REPORT: Macquarie River CBD Master Plan

AUTHOR: Liveability Architect
REPORT DATE: 28 March 2020
TRIM REFERENCE: ID20/275

Figure 2. Proposed structural elements.

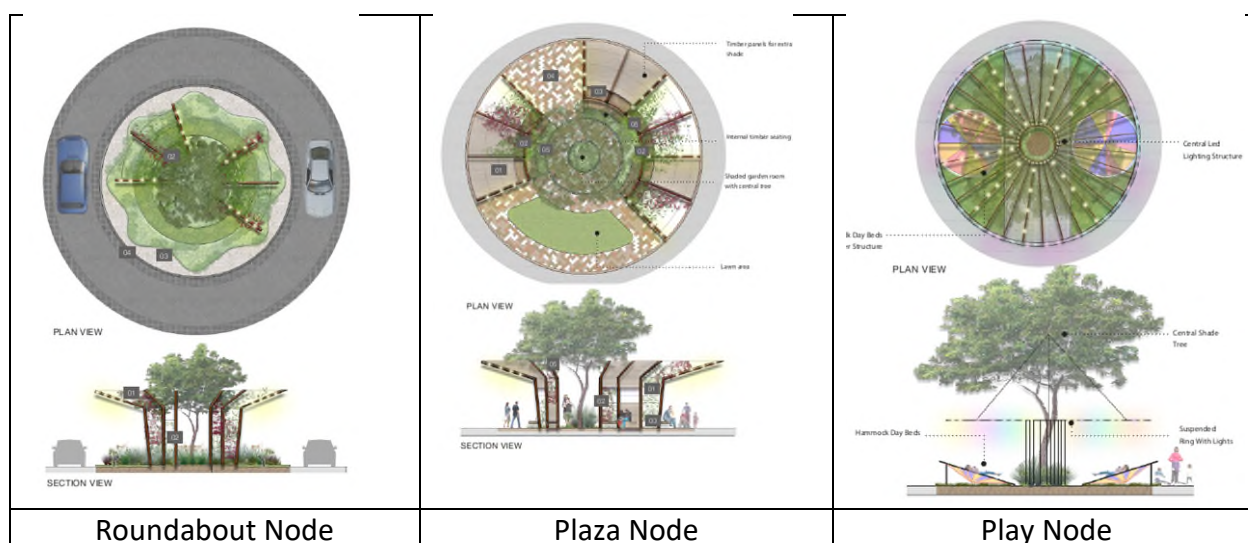
8. The sculptural elements look okay, please make them natural, organic shapes, not hard, and artificial. Use local trades' people and artists to do the work. Most importantly just do it, don't talk about it and do nothing (Regand Park pie in the sky plans).

43. Sculptural - Great idea, however think they should celebrate a connection of place to the local Wiradjuri people.
44. Sculptural - By all means get sculptural, but don't go nuts – Sculptural round about pontoon is a bit much.
49. Sculptural - Use of extensive solar lighting for extended usage and security purposes should be the focus with sculptural art work something that can be added over time, and perhaps an event could be held to encourage artists to submit designs and construct at own cost for an award? This would give us greater use of ratepayer funds.
54. Sculptural - It's good place for community events.
57. Sculptural - Love to see some Aboriginal designs and stories. Maybe something that talks about the Aboriginal land, which tribe people.

The structural elements designs are still to be finalised. However, there is an opportunity to include indigenous design elements into them to recognise Dubbo's Aboriginal cultural history. Council will engage with the local Aboriginal community through the Wiradjuri Technical Advisory Panel.

As part of the proposed designs, the structural elements will include LED lighting to add both decorative and additional security lighting into areas, as well as the incorporation of features such as misting systems (plaza nodes), to add an additional cooling mechanism to combat the heat of summer.
